| Flight Procedure Tracking Form | | Action: FLIGHT CHECK | Task Type: IAP | Date Open: 09/11/2017 | Task #: 2015052836140403003 | Request #: 20150528361404 |
| Procedure: RNAV (GPS) RWY 20 AMDT 1 | | | | Airport ID: PABT | Airport: BETTLES | Reimbursable #: NO |

RNAV (GPS) RWY 20

**DEPARTMENT OF TRANSPORTATION
FEDERAL AVIATION ADMINISTRATION
CATEGORICAL EXCLUSION DECLARATION**

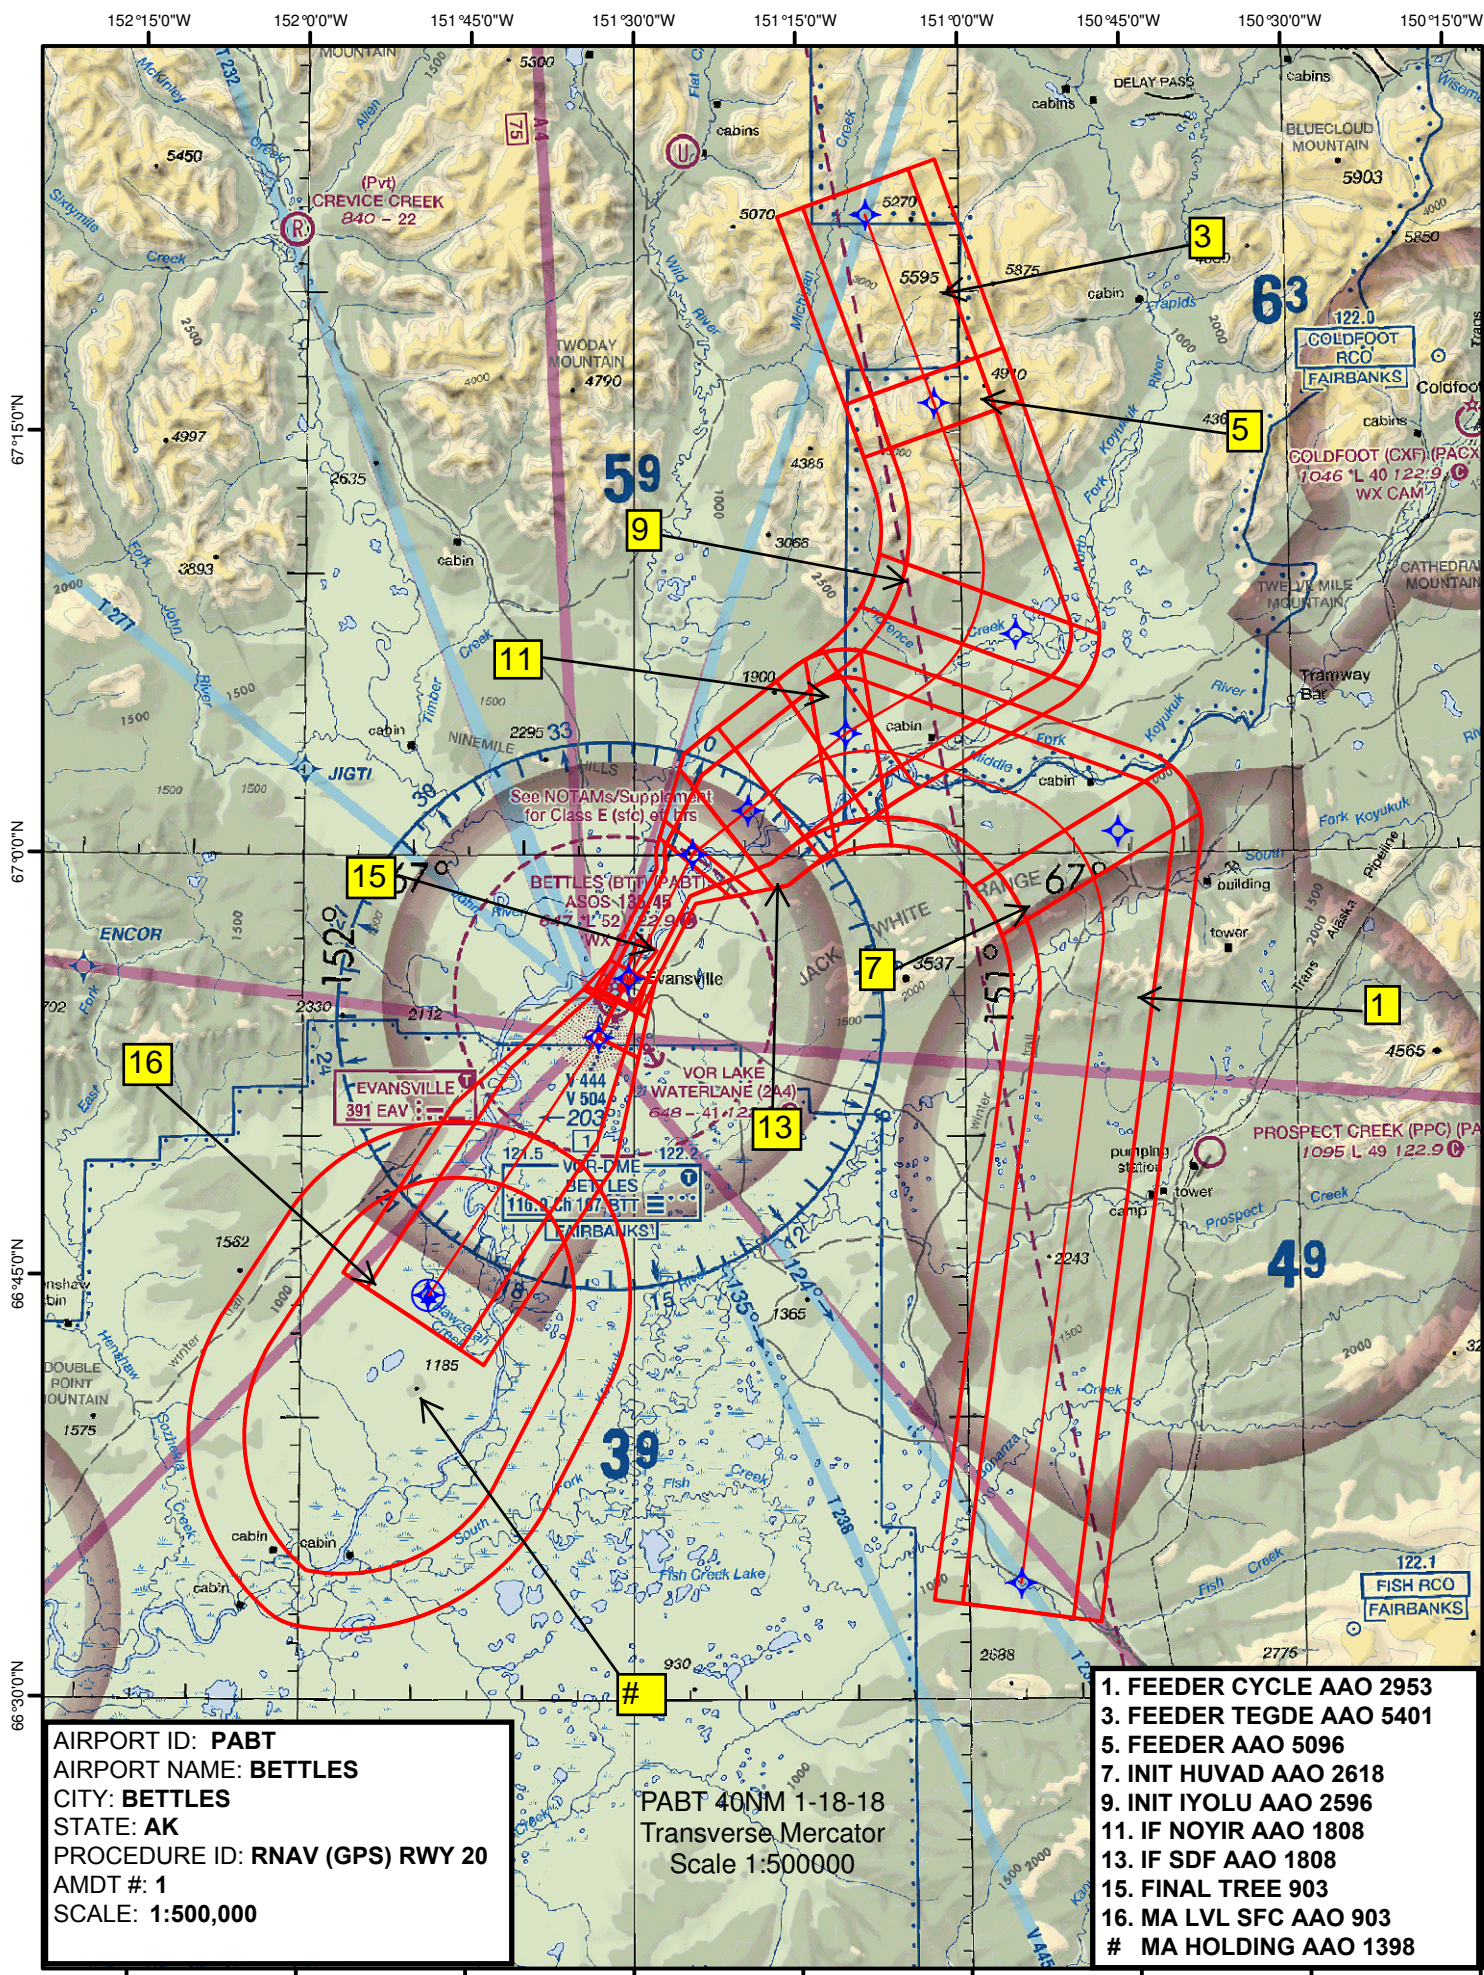
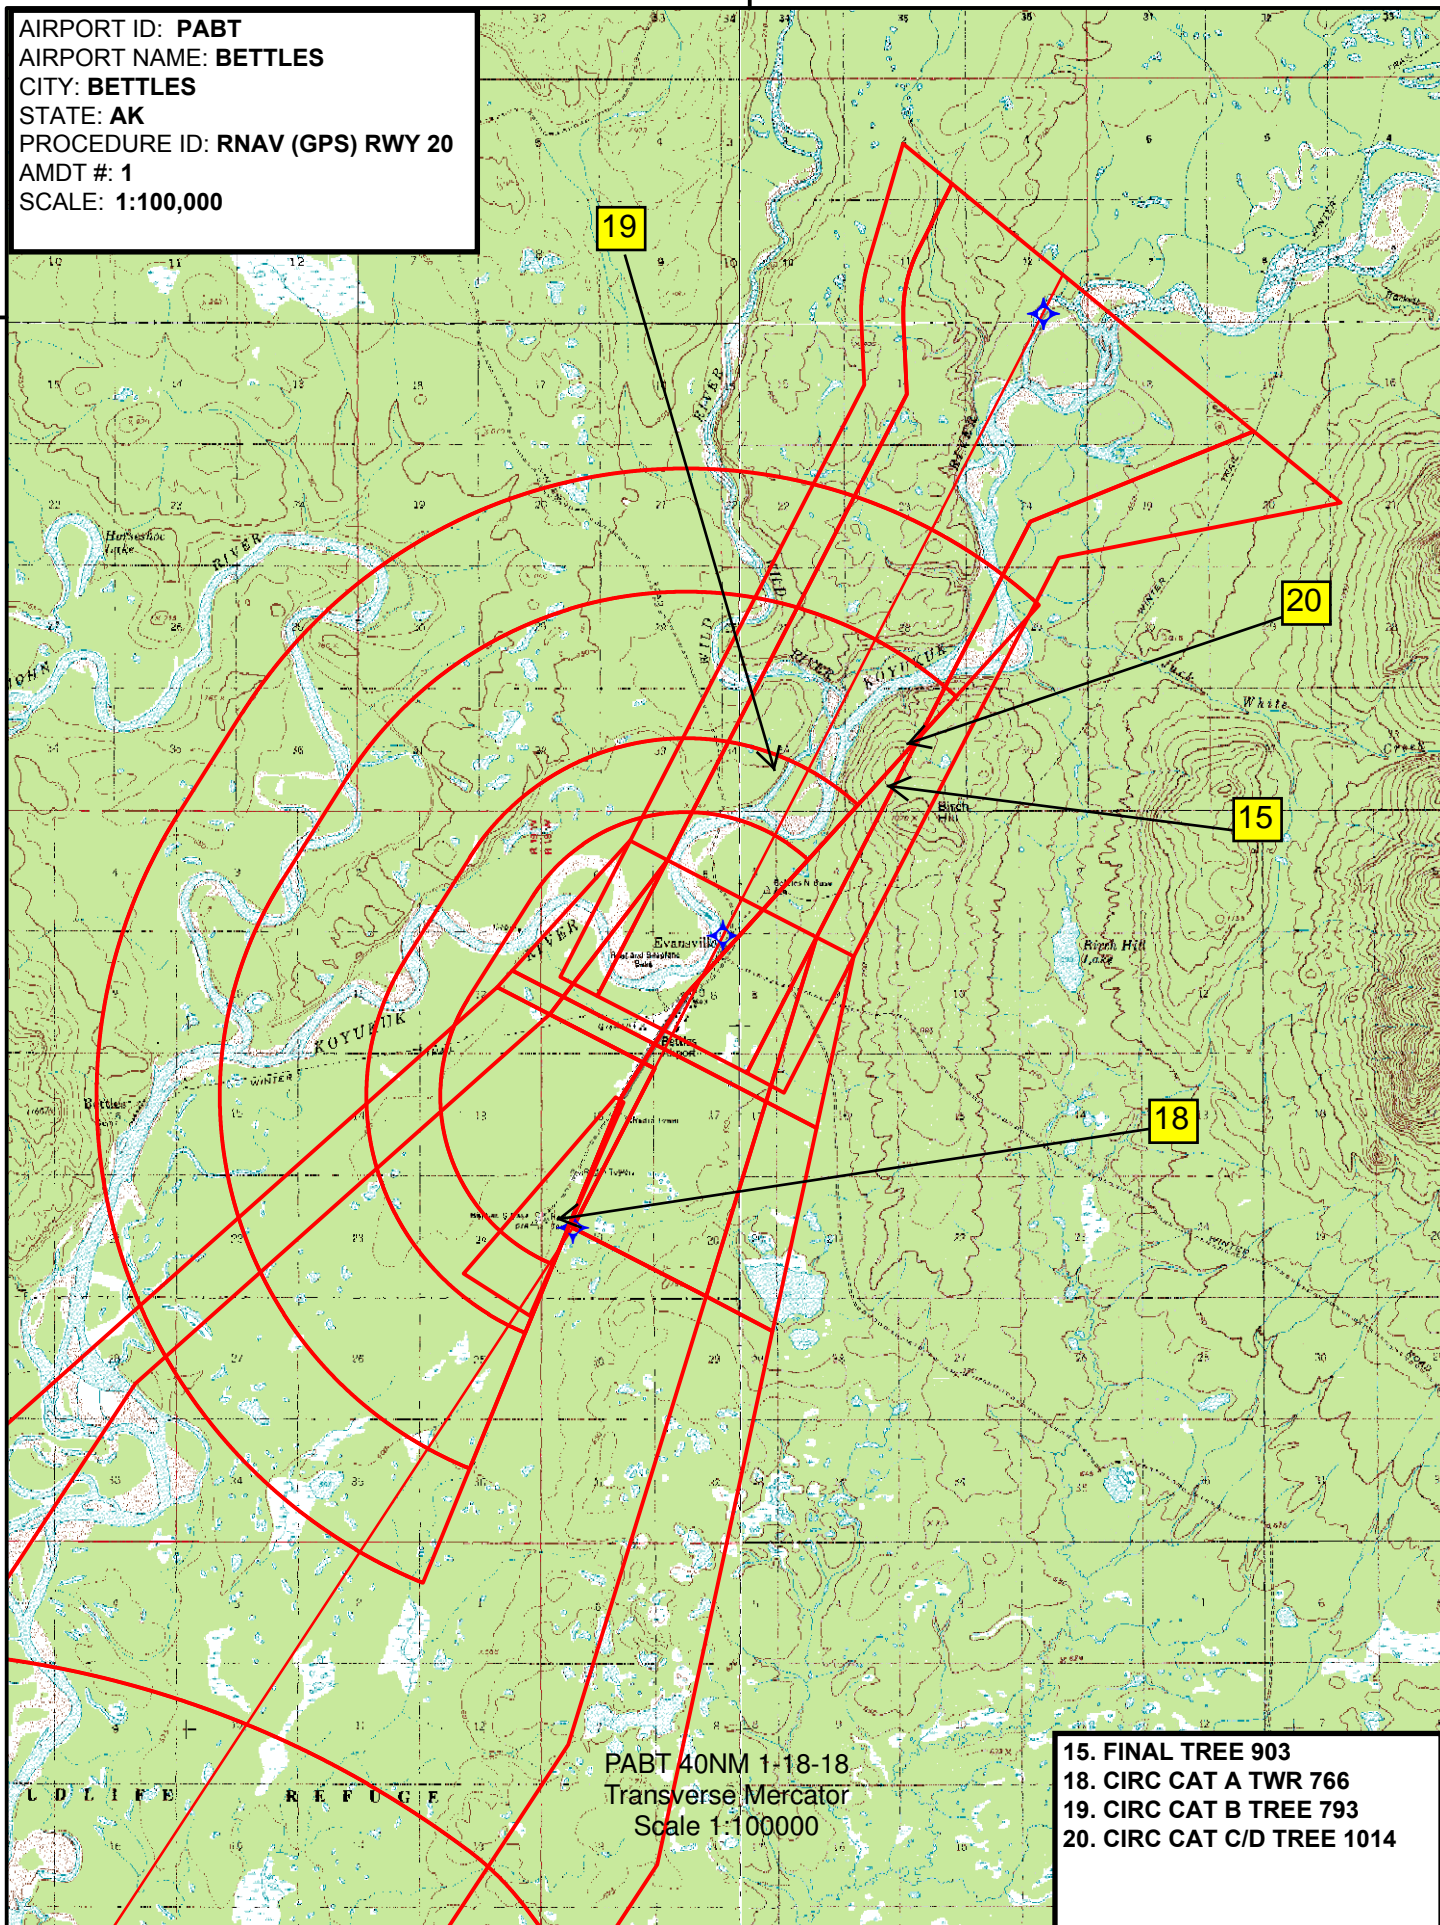
1. changing the procedure name to RNAV (GPS) RWY 20 to update the runway number;
2. fix NOYIR will move 3,217 ft. along its existing track towards the threshold;
3. fix WUTOM will move 9,013 ft. along its existing track towards the threshold; and
4. fix OCUKU will move 314 ft. south along its existing track for connectivity due to NOYIR and WUTOM moves.
